Keri Keri Wind Farm – Response to Submissions (TfNSW)

Amber Organisation has been engaged to assist with response to agency advice received from Transport for NSW (dated 11 March 2026) related to Keri Keri Wind Farm. Table 1 provides a summary of the comments which have been addressed herein.

Table 1: TfNSW Response to Submissions

Keri Keri Wind Farm - OSOM Routes 1A/1B/2A/2B
KM Index 83.0/158.0: Sturt Highway / Market Street, Balranald
Strategic Concept Design

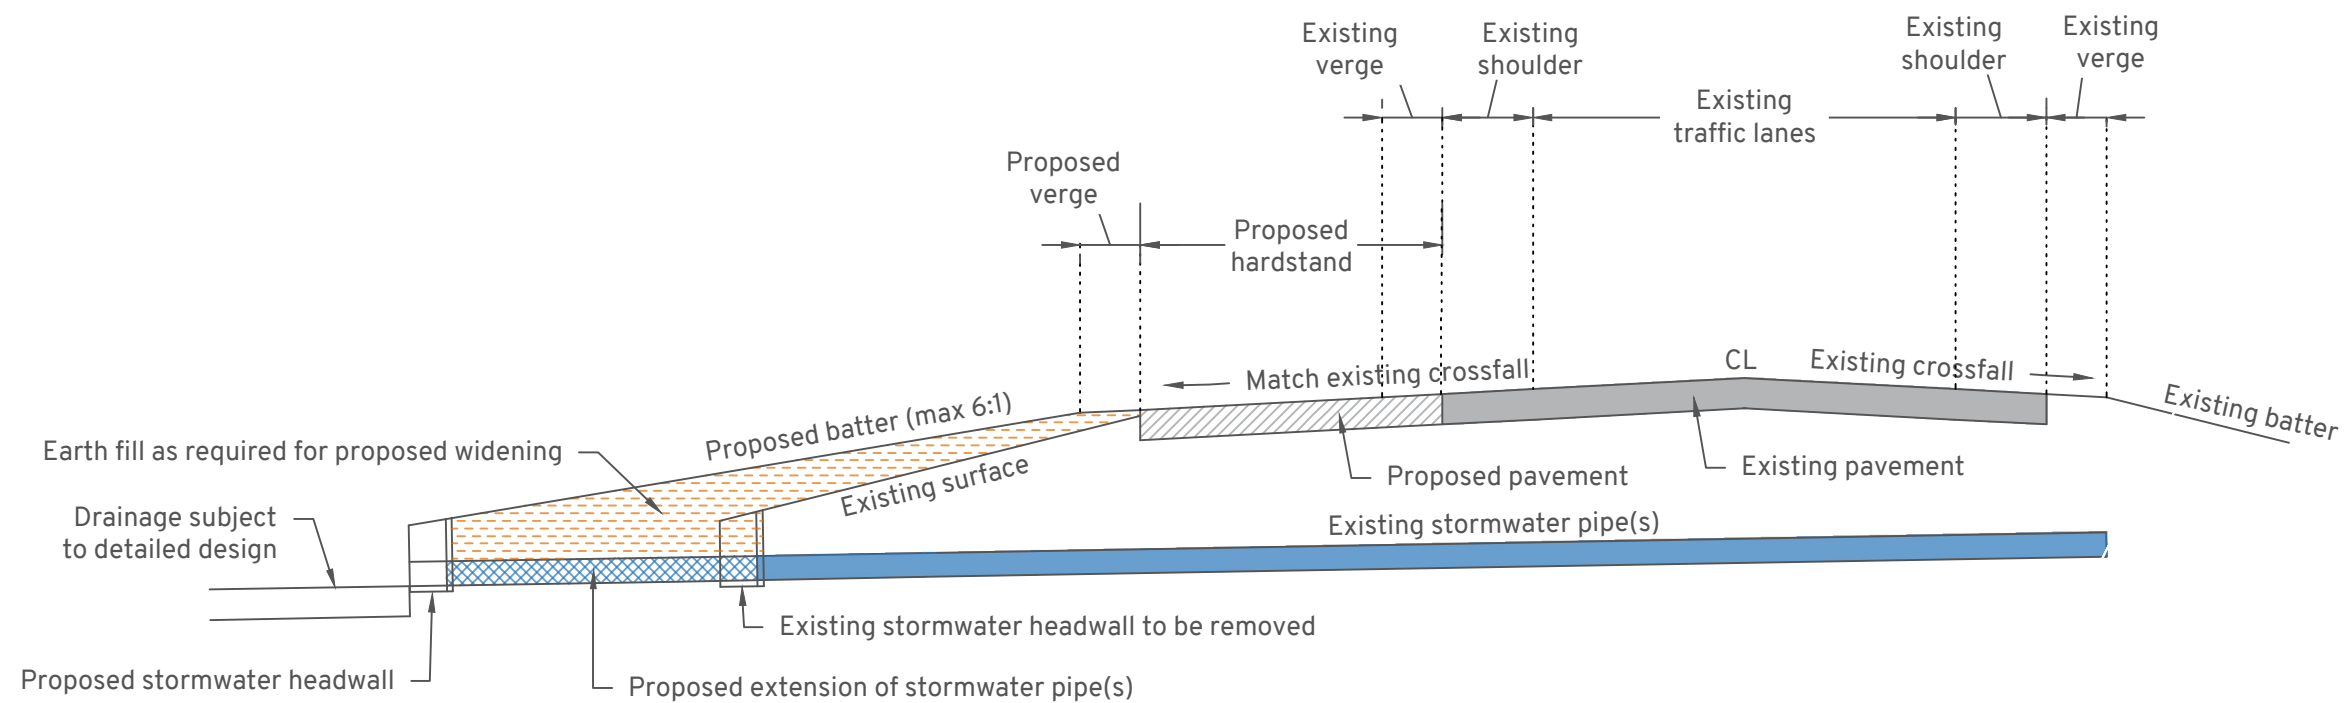
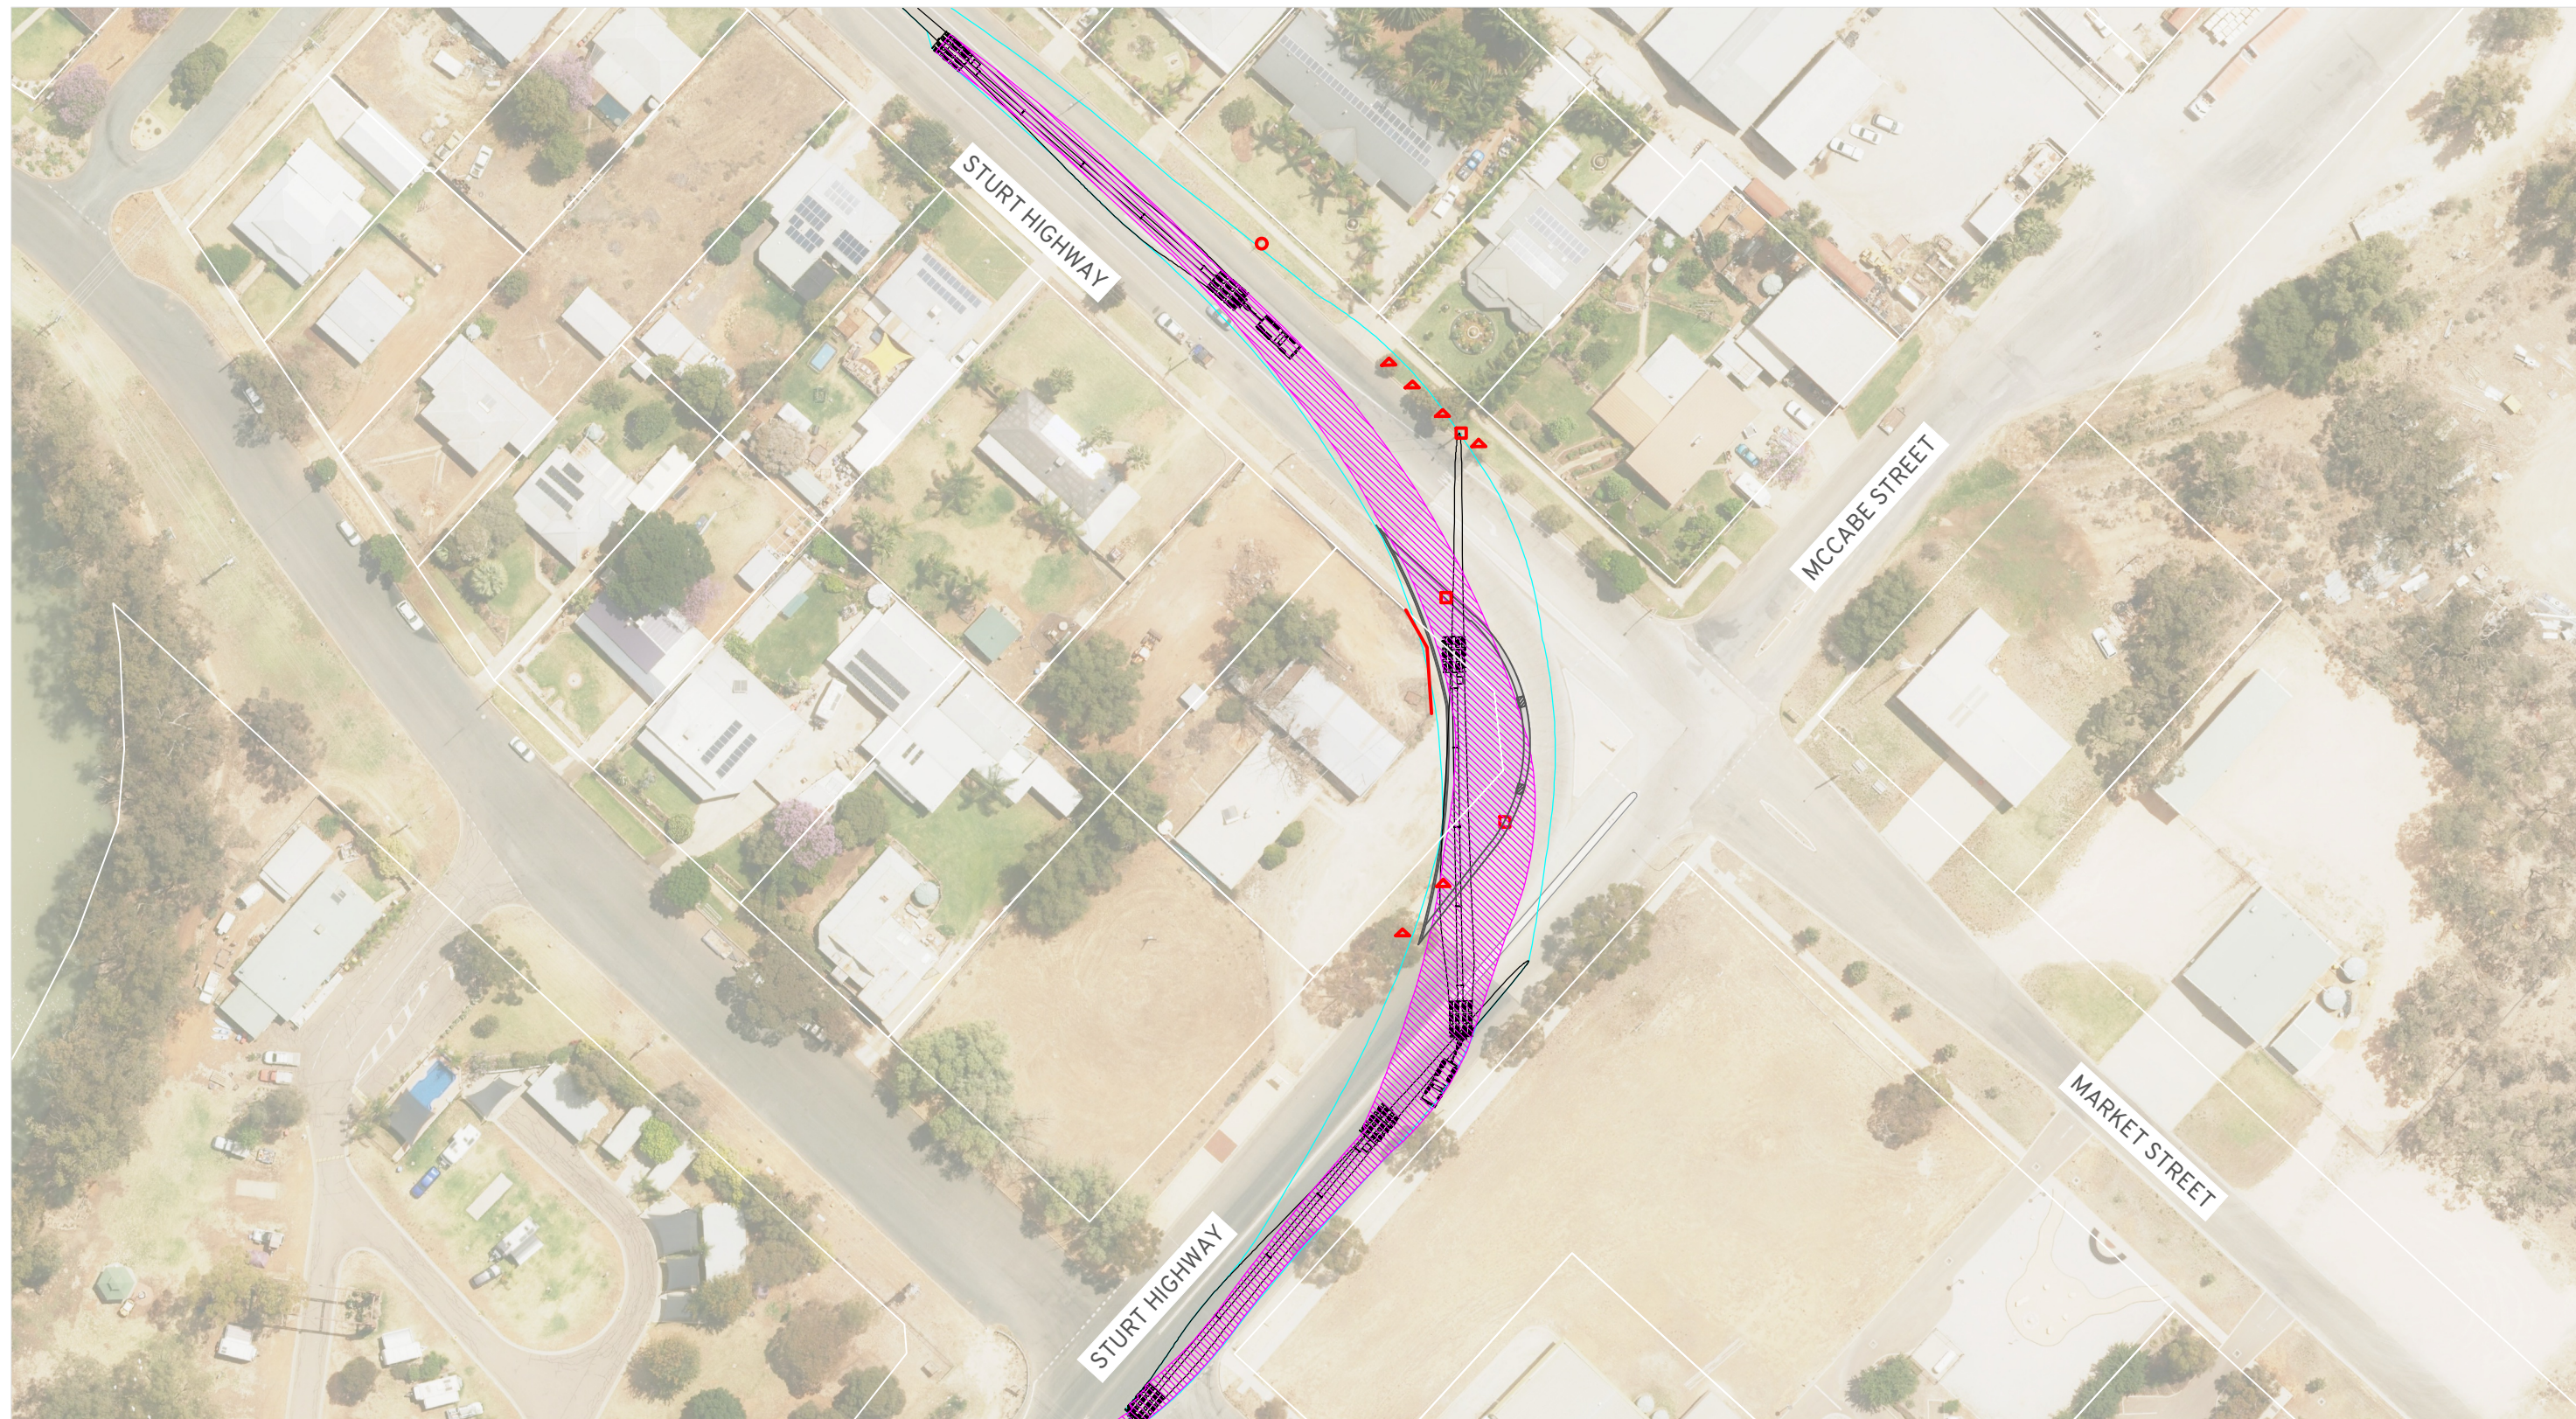
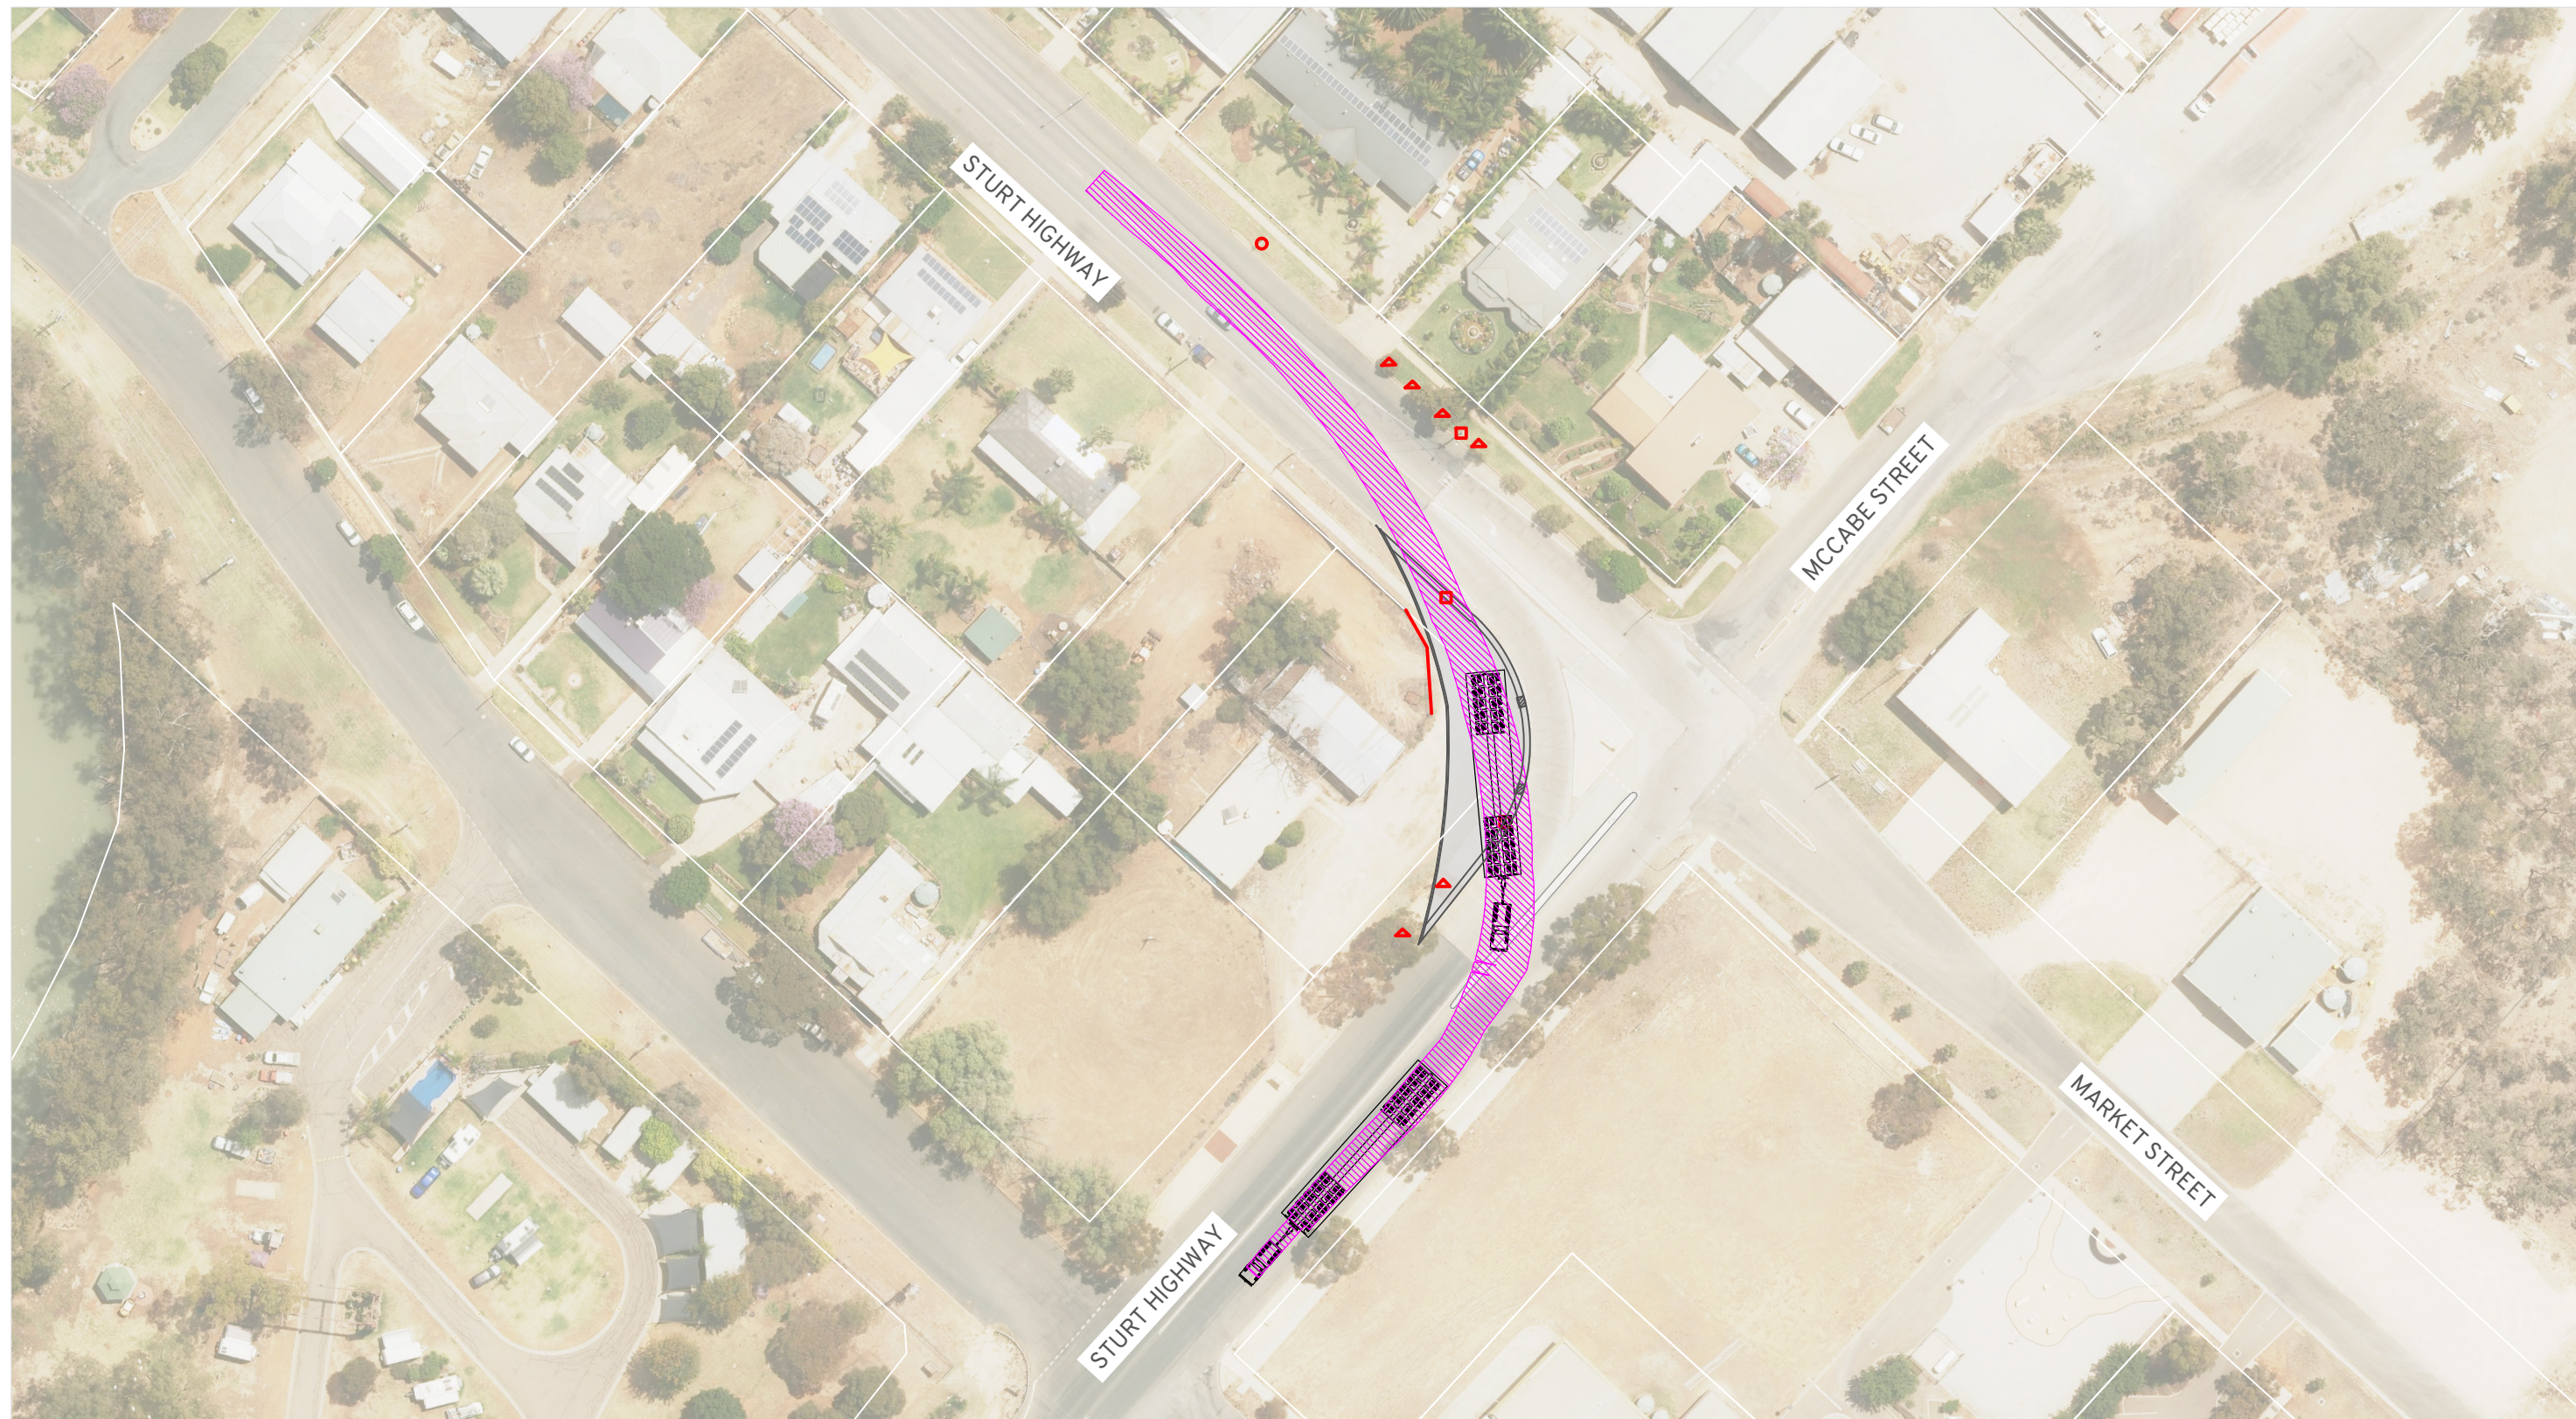
3g	<u>g. Revision D Civil Design RJ Andrews SPA - Sturt Highway at Euston</u> - TfNSW requires a strategic concept hardstand design prior to determination, that includes the kerb replacement, existing drainage and other infrastructure checks that will impact on the scope of the road upgrades/modifications.	Strategic concept design for this intersection is provided in Appendix A (Sheets 08-10). The design includes a dish crossing with trafficable grates to facilitate movements onto the hardstand area.
3h	<u>h. Revision D Civil Design RJ Andrews SPA - Parking Bay @86m near Balranald (Left turn into Duryea Street)</u> - The proposed parking bay is adjacent to the left turn lane into Duryea Street and private service centre. It is unsealed and poses safety concerns given the number of conflict points at this location. Is there another viable location with reduced conflict points that can be utilised/constructed?	This parking bay is no longer proposed to be utilised. An alternative location where OSOM vehicles would be able to pull over if required is available in Balranald along Sturt Highway (Market Street) adjacent to Balranald Lions Park, as outlined on page 49 of the RJA report (Revision 03).
